# PRELIMINARY DRAINAGE REPORT

## CROSSROADS MIXED USE EL PASO COUNTY, COLORADO

Project #18-003A  
PCD Filing No.: SP-20-011

**Routed Hydrograph Results**

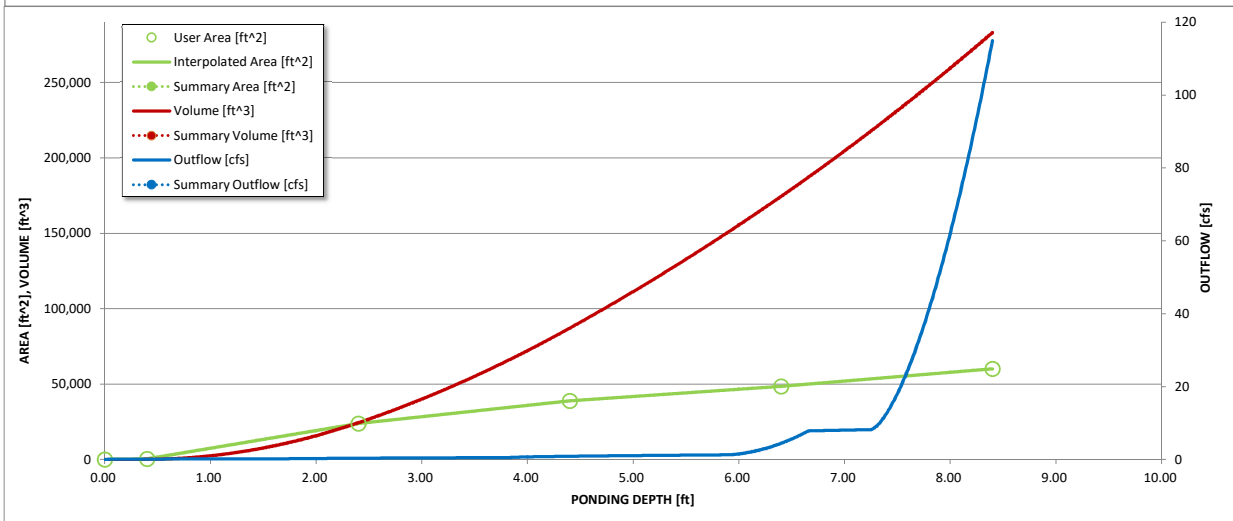
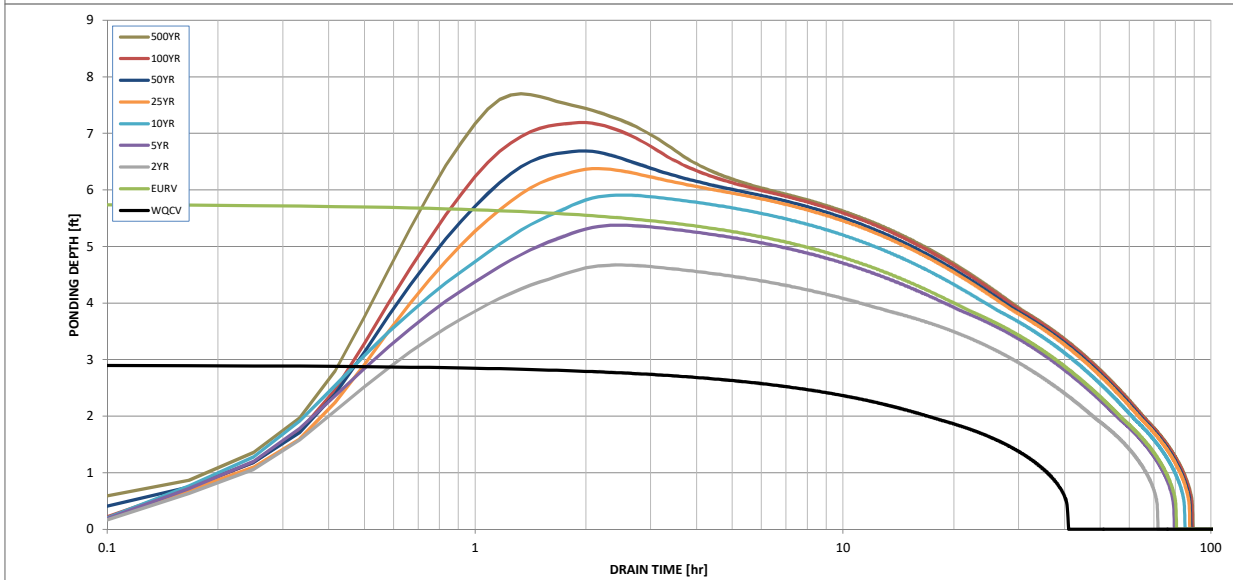
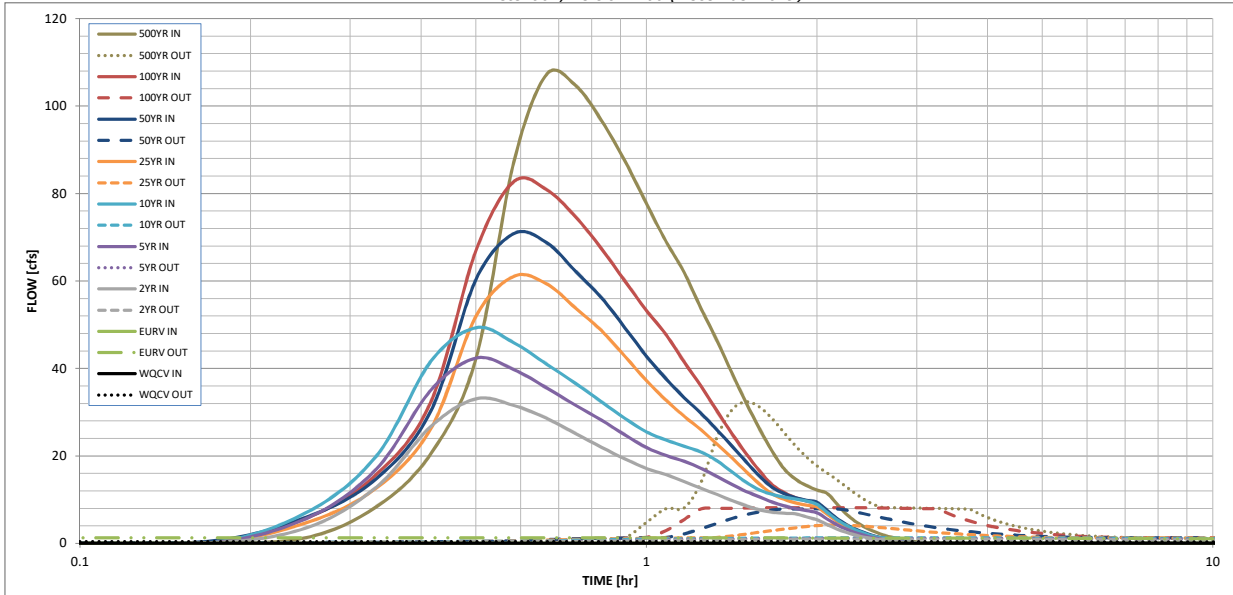
Revise. Must be at or below predevelopment. Unresolved.
